Amendment No. 1

Tender No. HSCC/KCGMC/PACKAGE-II/2013

Project Name - Construction of Hospital, OPD & other Associates Works including dismantling of existing buildings & their foundation for Kalpana Chawla Govt. Medical College (KCGMC), Karnal, Haryana.

Reply of Bidder's queries raised during Pre-bid meeting held on 19.06.2013 at HSCC, Head Office, Noida.

SITE LAYOUT PLAN

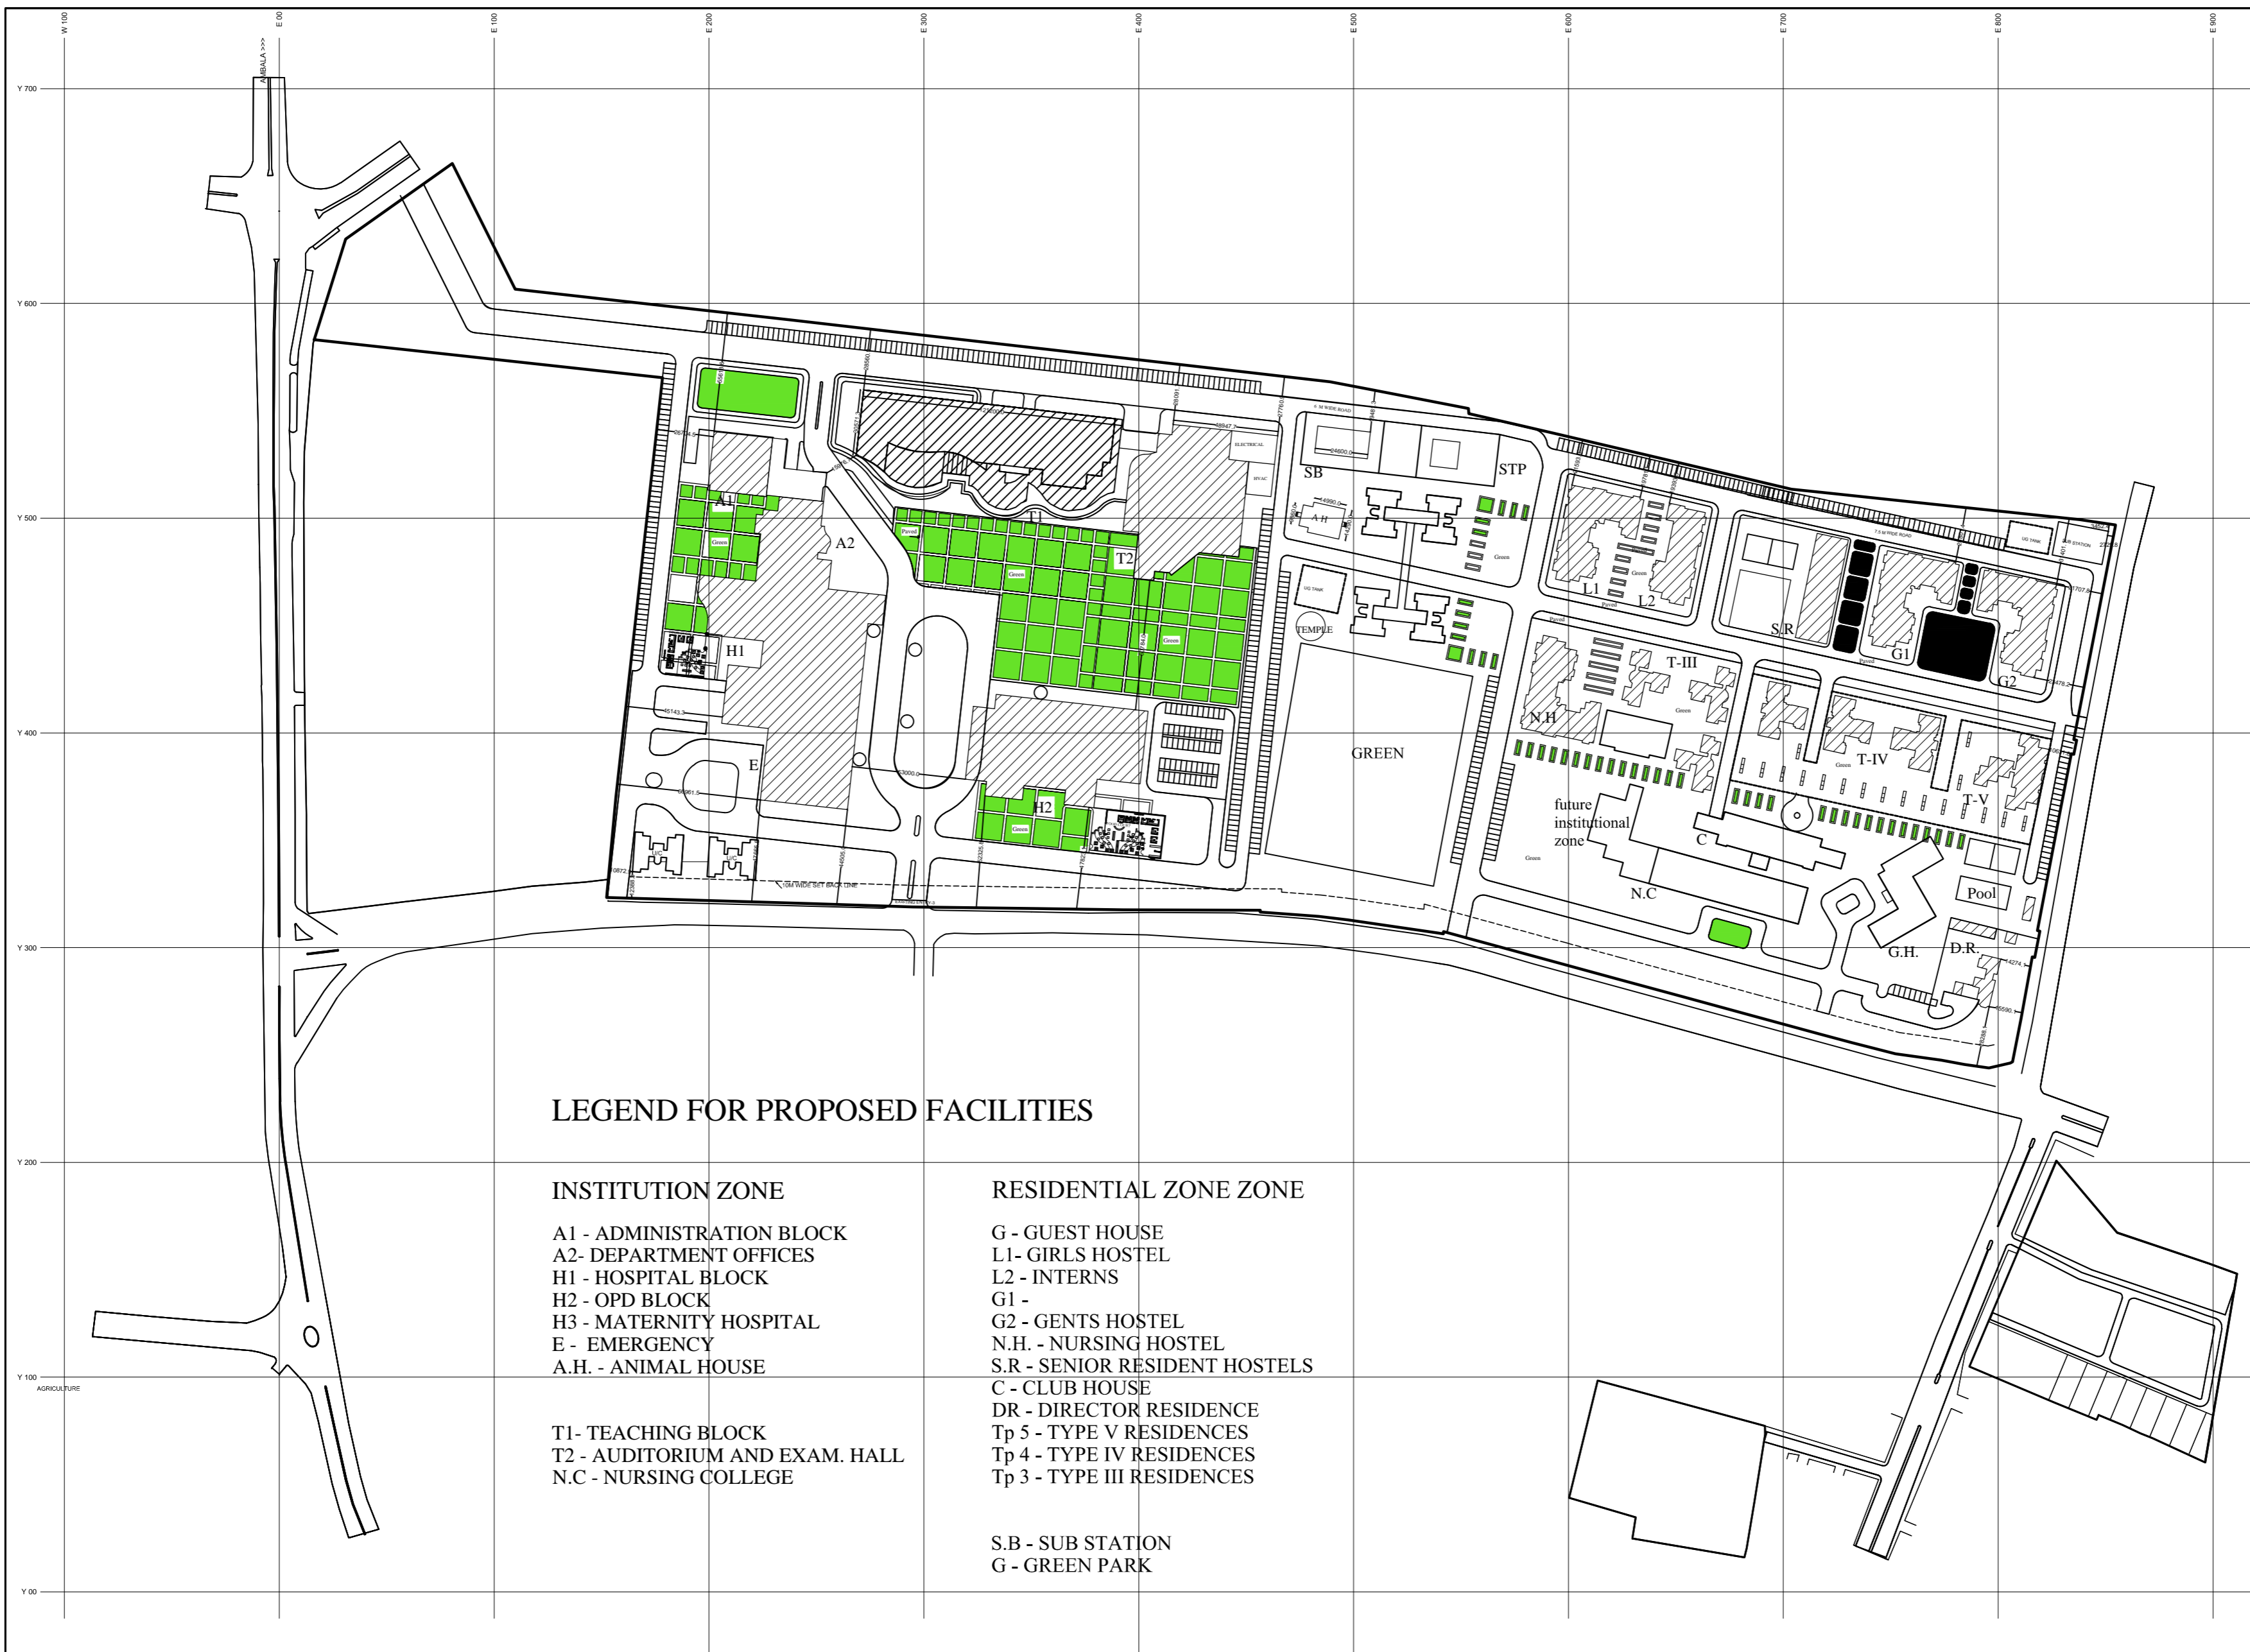
Master Plan mentioning the existing infrastructure proposed construction structures.	bidder.
8.	The project duration is 20 months. Whereas the milestone mentioned in the table are not in consonance with the project duration of 20 months. Kindly look into the same and provide us the revised Milestones commensurating with the project duration of 20 months.	Shall be as per Tender Condition.

7.	We request you to kindly provide the	Has been uploaded with this reply to

ELEVATION A
ELEVATION B

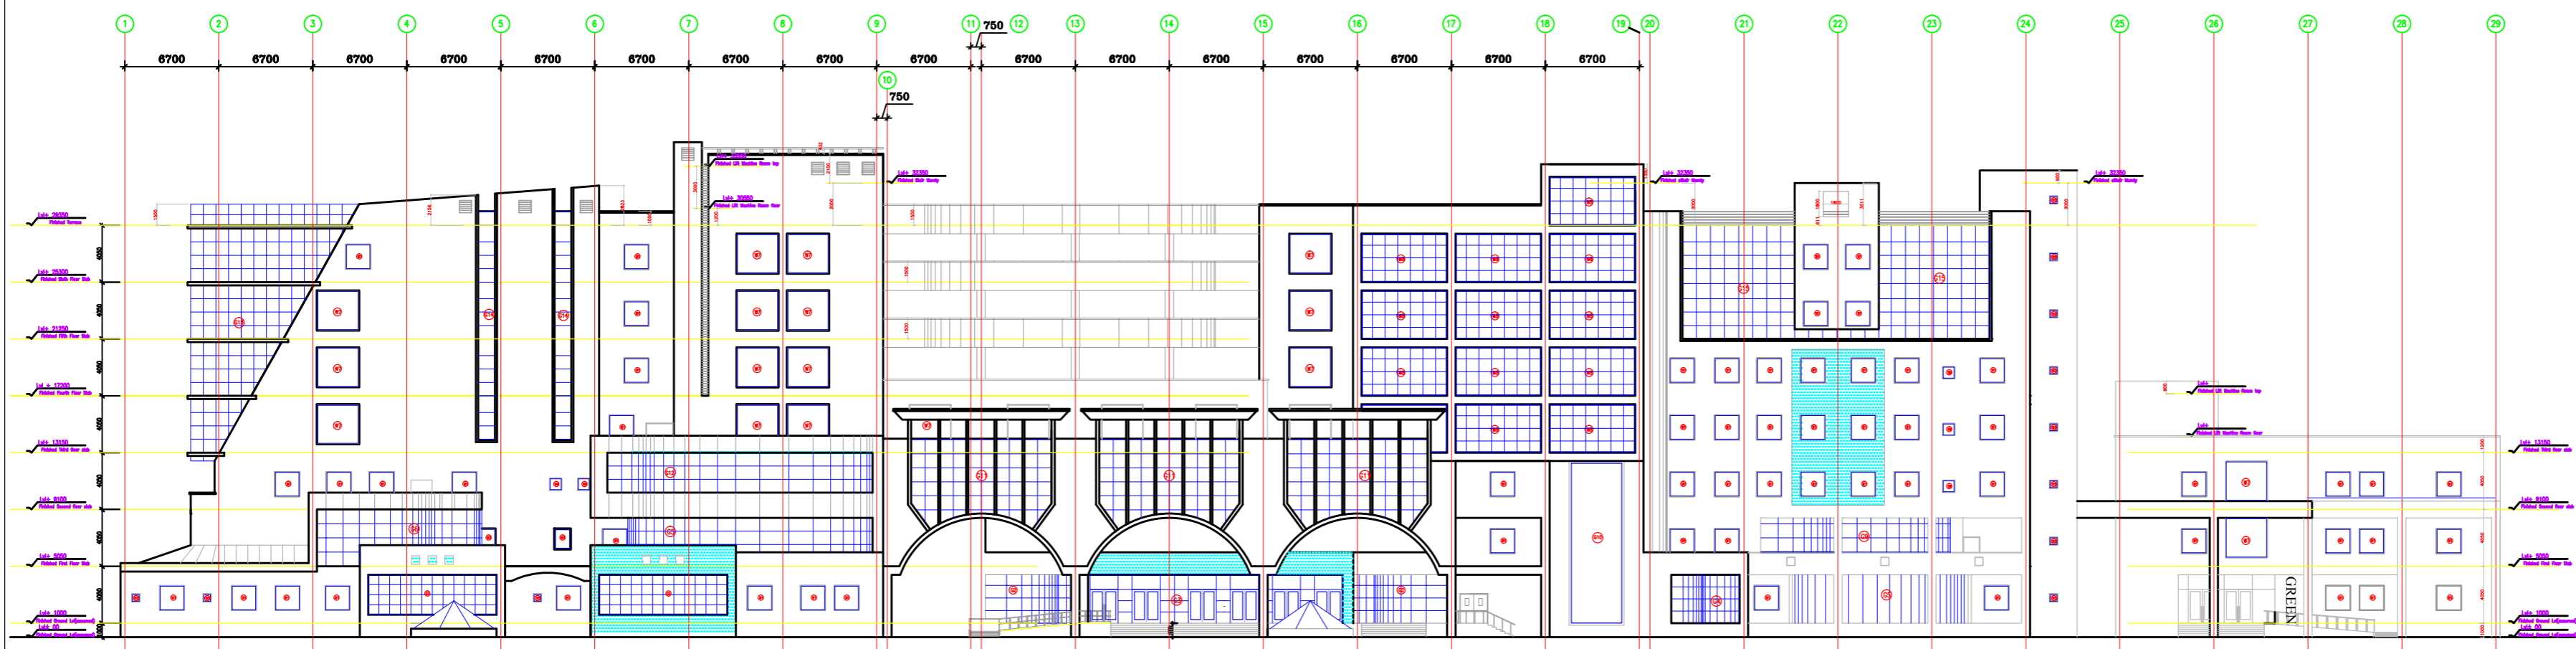
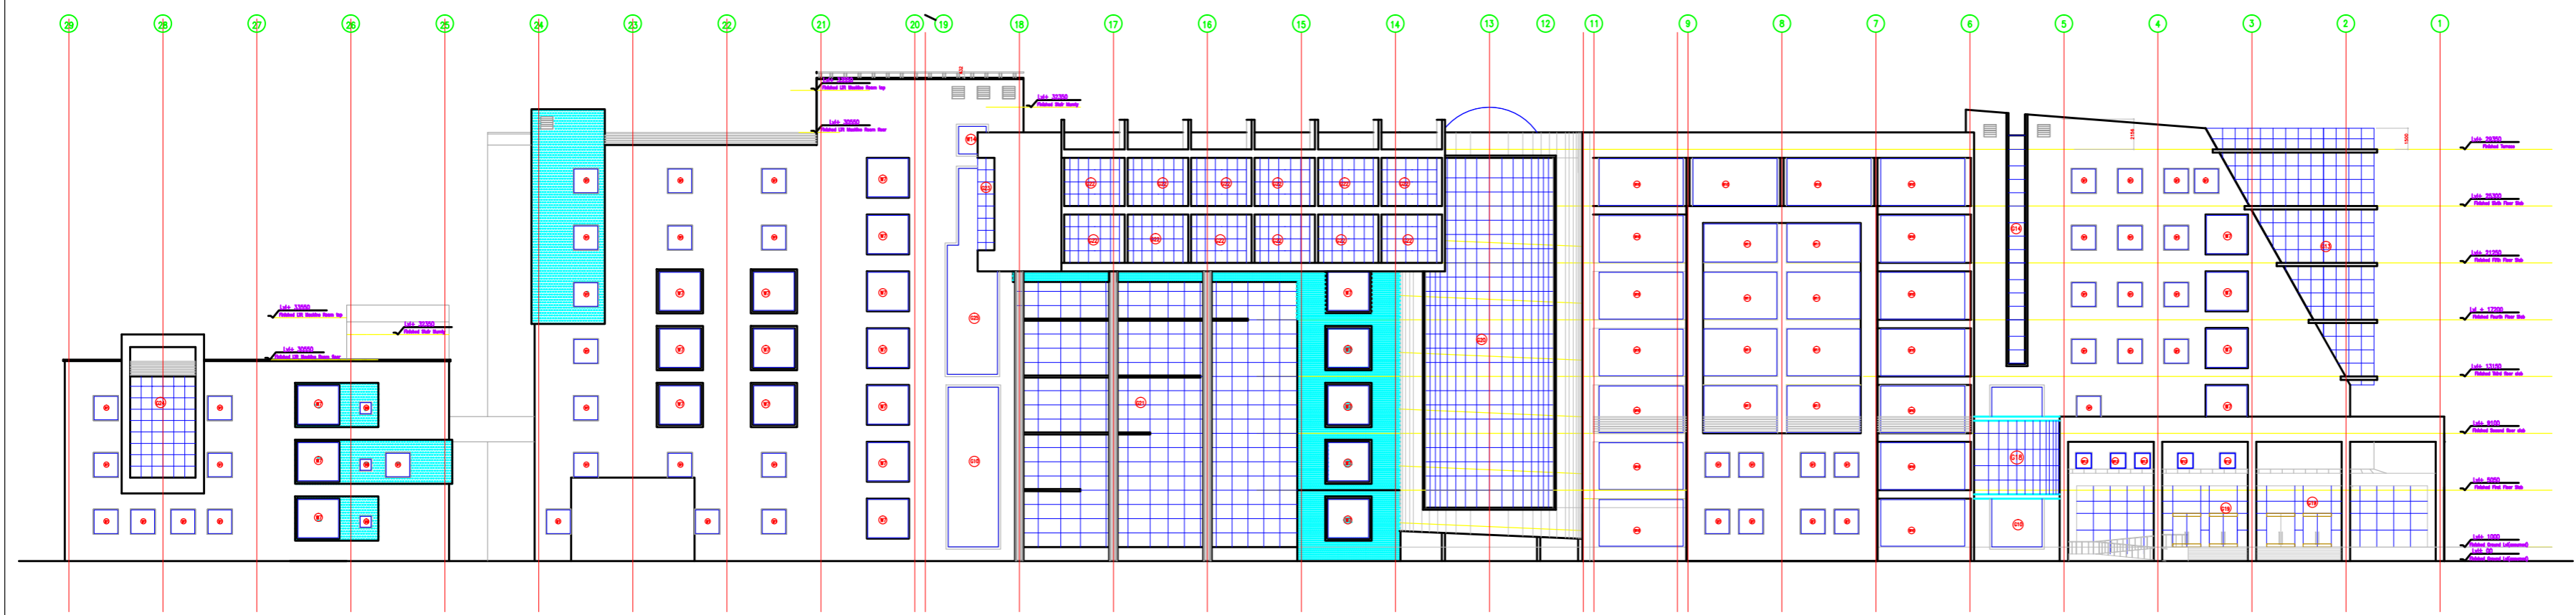
34.	<p>Request to provide Elevation & Cross</p>	Has been uploaded on web site along with

sectional drawings for hospital & OPD Block.	this reply.
35.	Request to provide soft copy of tender drawings to enable us to study it and submit our most competitive & comprehensive bid.	Tender drawings already available at tender web site.
